## Stakeholders' position to questions raised in CENELEC's slides

### Question 1: Other active power setpoints during LFSM - O

#### Question 4: LFSM-O operation with hysteresis

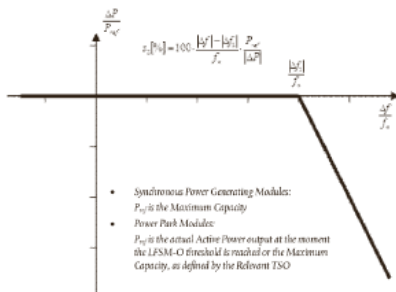
Is a LFSM-O implementation including a hysteresis as proposed below in conflict with Article 13 2?

Considering the characteristic included in the question of CENELEC, even though it can be considered as being more relieving than a proportional droop, it bears the risk of jeopardizing system stability. Therefore, the characteristic included in CENELEC's original question shouldn't be used.

The proposed characteristic will put the secure operation of the system at risk. The problem is that modern inverters can follow the characteristic very exactly and quickly, including the steep ramp when frequency reaches slightly less than 50.01 Hz. A similar characteristic was used in Germany in the past. Tested inverters show a behavior as depicted in Figure 1:

Article 13(2)(a) defines: “the power-generating module shall be capable of activating the provision of active power frequency response according to figure 1 at a frequency threshold and droop settings specified by the relevant TSO”.

Figure 1 defines the course of the active power frequency response:

Above the frequency threshold to be defined by the relevant TSO, the active power output shall vary in a linear way as a function of frequency. The gradient of the active power variation is defined by the droop, which shall be also specified by the relevant TSO. Article 13(2)(a) does not distinguish between a decrease of active power output in case of increasing frequency and an increase of active power output in case of decreasing frequency, therefore in both cases the linear variation according to figure 1 shall apply. A hysteresis as proposed by CENELEC is not foreseen by the text of Article 13(2)(a).

**Figure 1: Active power reduction due to over-frequency of a PV-inverter with high output power (red: frequency, black: output power)**

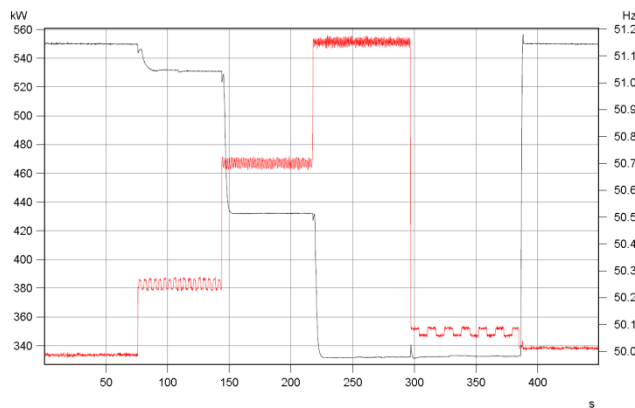
In a system, such steep ramps will lead to an overshoot of generation when frequency drops back to 50.0 Hz. Taking into account the slow answer of reserves, frequency will deviate again, as Figure 2 reveals<sup>1</sup>:

To avoid such an unsatisfying behavior, the characteristic as proposed by CENELEC should not be used.
